## USB72x6/USB7252 Silicon Errata and Data Sheet Clarification

This document describes known silicon errata for the following USB72x6/USB7252 devices:

- USB7206
- USB7216
- USB7252

**FIGURE 2: TYPE-C DISCHARGE WORKAROUND FOR MODULE 3**

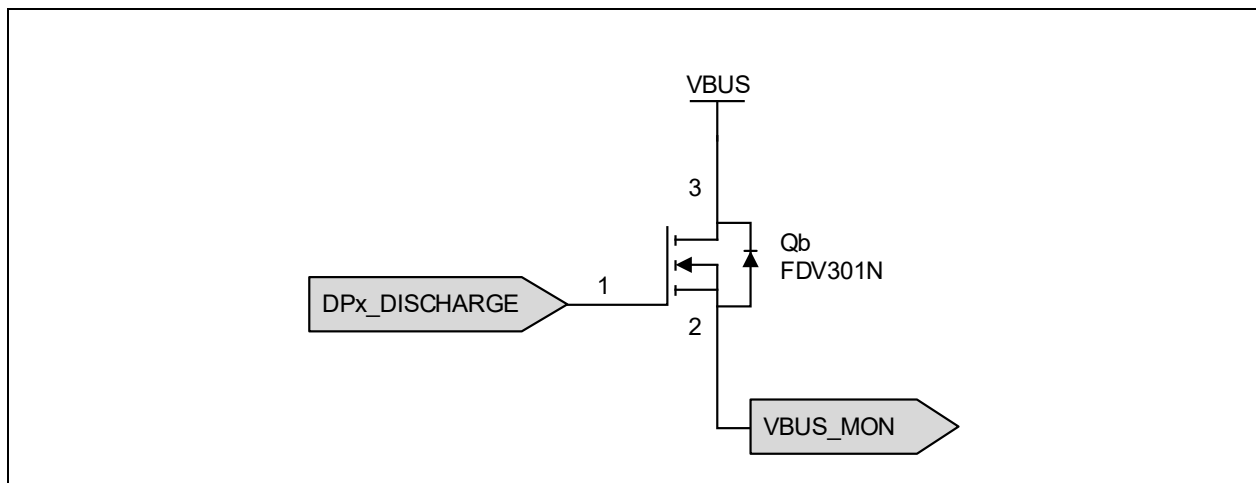
One requirement for USB-IF compliance certification of a system with an exposed Type-C port is the *Port Power On/Off* test. This test is part of the HUBCV suite of *Command Verification* tests for USB 2 devices. As part of this test, the hub must discharge VBUS, and then energize VBUS in response to CLEAR\_FEATURE and SET\_FEATURE commands from the test host.

Frequently, these ports will be implemented with electrolytic VBUS load capacitors, which retain a small residual charge that is released slowly compared to the timing of the discharge. In such cases, as energy is released from the capacitor the voltage can drift upward slightly after the discharge, which can cross the VBUS\_DET threshold for detecting VBUS high. In the sequence of the Port Power On/Off test, this can inhibit subsequent turning on of VBUS in response to commands from the test host and the test fails.

Type C ports that have a large electrolytic capacitor may require this workaround to pass the HUBCV Port Power On/Off test.

In reference designs for USB7216 and USB7252 devices, an N-channel MOSFET with a  $V_{GS}$  less than 1.0V is connected between VBUS and VBUS\_MON, with gate control from the DISCHARGE signal. This additional component creates an additional current path as the discharge is monitored by VBUS\_MON, which biases VBUS\_MON higher. This results in discharge to a lower voltage than what is otherwise achieved, and compensates for any residual energy that the capacitor releases after the discharge. At times other than the discharge, the MOSFET is turned off and does not influence VBUS.

No components of the reference design need to be removed; only the MOSFET is added.
